## Addendum #5

October 26, 2018

Project:             32 Unit Development  
Smith Drive  
County Road No. 30  
Havelock, ON

| <b>SEAL:</b><br>   | <b>DRAWN BY:</b><br>SANDY      | <b>PROJECT #:</b> 17019   | <b>Gregg Gordon Architect</b><br>516 Hunter Street West<br>Peterborough, Ontario K9H 2N1<br>Tel. (705) 876-6548<br>Fax. (705) 876-9206 | <b>PLOT DATE:</b><br>Oct. 26, 18  | <b>DWG #:</b><br><b>SK-5.1</b> |

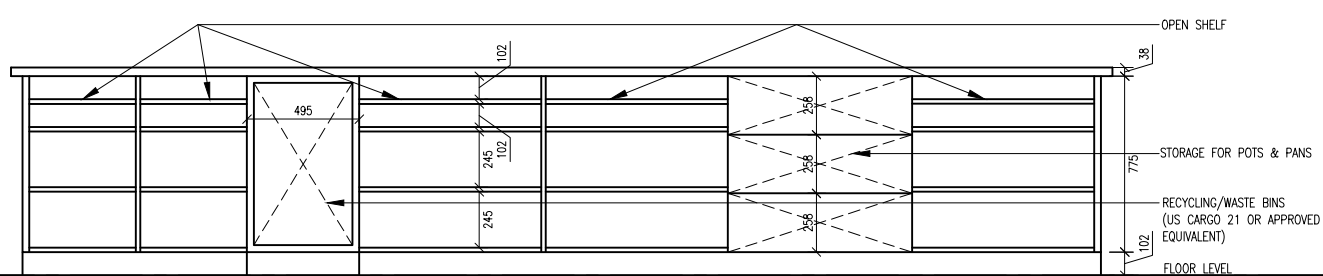
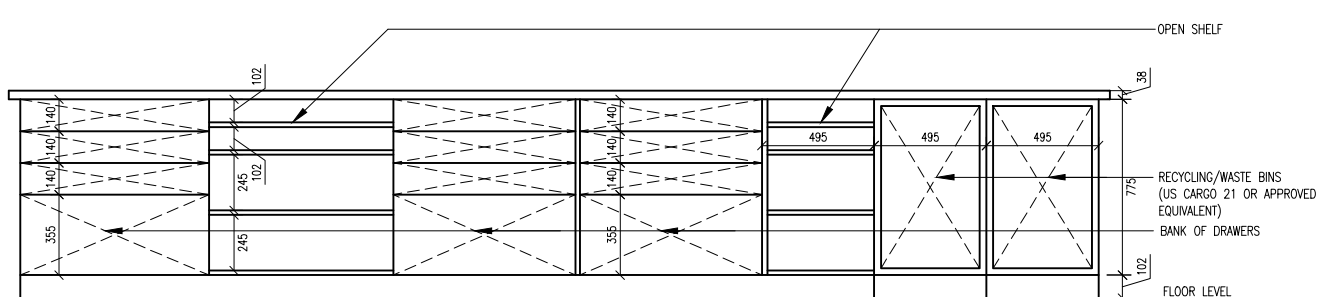
The Island Millwork in the Commercial Kitchen was inadvertently left off of the original Architectural drawings. The drawing has been included here as Sketch Detail SK5.1. As earlier stated, all millwork shown on the drawings is to be included this Contract: millwork is not considered to be "Appliances or Equipment".

SLIDE OUT FULL HEIGHT DRAWERS WITH REMOVABLE PLASTIC BINS FOR REFUSE & RECYCLING BINS ACCESSED FROM BOTH SIDES OF ISLAND

NOTE 1:  
 RECYCLING/WASTE PULLOUT DRAWERS COMPLETE WITH CABINET FACE AND DOUBLE BIN CABINET. PLASTIC BINS TO BE REMOVABLE AND SIZED AS 559MM (22") FRONT TO BACK X 495MM (19 1/2") WIDE X 507MM (20") HIGH, WITH POWDER COATED STEEL LID TO SEAL TOP OF BINS, US CARGO 21, EACH BIN 40L. AS SUPPLIED BY HAFELE CANADA INC. (800-423-3531) OR APPROVED EQUIVALENT.
